NAME	DATE
DRAWN		Mittwoch, 4. August 2021
CHK'D		A-01
Scale 1:1	SHEET 11 OF 11	A4

SAC PU J5 B ST

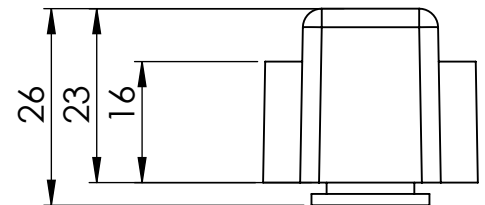
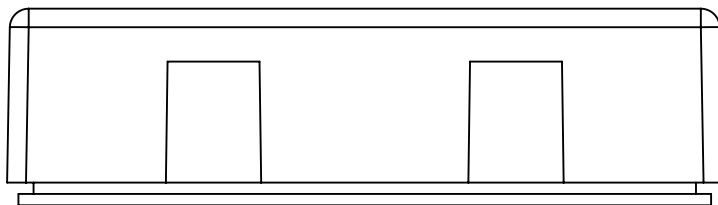
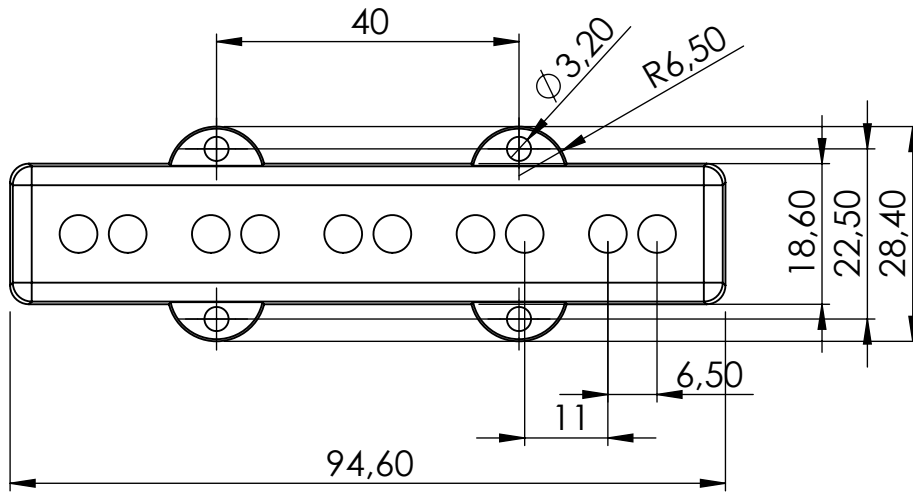
Please add additional 4mm in total height to compensate for the pickup cable!
